**36 CFR Part 1192**

**49 CFR Part 38**

**Americans with Disabilities Act Accessibility Guidelines for Transportation Vehicles; Over-the-Road Buses**

**ACTION:** Joint final rule.

**Figure 1**  
**Wheelchair or Mobility Aid Envelope**

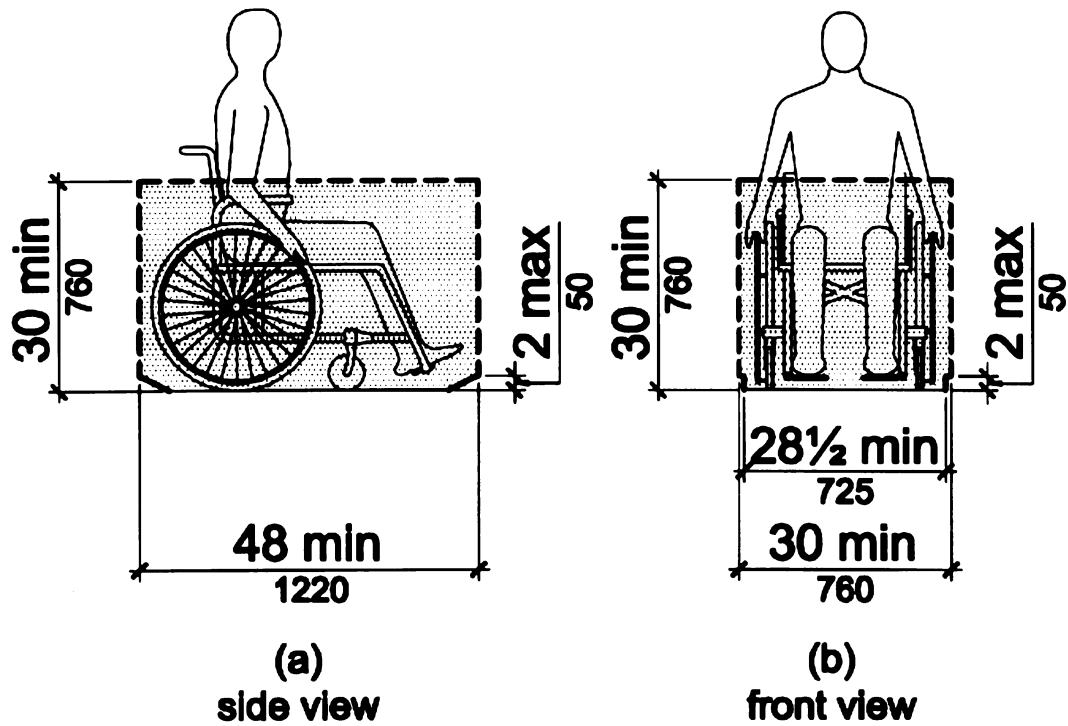
A total of 14 comments were received by the Board in response to the NPRM. One comment dealt only with issues raised by the Department of Transportation's NPRM and did not address any items under consideration by the Board. A comment submitted by a public transit operator wanted changes in the number of wheelchair or mobility aid seating locations for a 96-inch wide bus. However, public operators are subject to section \_\_.23, which was not the subject of this rulemaking. A manufacturer of urban transit buses was concerned that some of the provisions would apply to such buses and wanted a change in the definition of an OTRB. A manufacturer of OTRBs also suggested a change in the definition because it claimed the current definition would not include a 45-foot OTRB. In fact, the definition at 49 CFR 37.3 does not reference any length.<sup>3</sup> Since the definition of an OTRB is statutory, the Board has not changed it. Also, since accessible restrooms will not be required, the proposed specifications have been moved to a new appendix section as advisory guidance. Figure 1 has been revised to conform to the text of the regulation.

7. Figures 1 and 2 are revised to read as follows:

(6) *Platform surface.* The platform surface shall be free of any protrusions of ¼ inch (6.5 mm) high and shall be slip resistant. The platform shall have a minimum clear width of 28½ inches (725 mm) at the platform, a minimum clear width of 30 inches (760 mm) measured from 2 inches (50 mm) above the platform surface to 30 inches (760 mm) above the platform, and a minimum clear length of 48 inches (1220 mm) measured from 2 inches (50 mm) above the surface of the platform to 30 inches (760 mm) above the surface of the platform. (See Figure 1 to this part.)
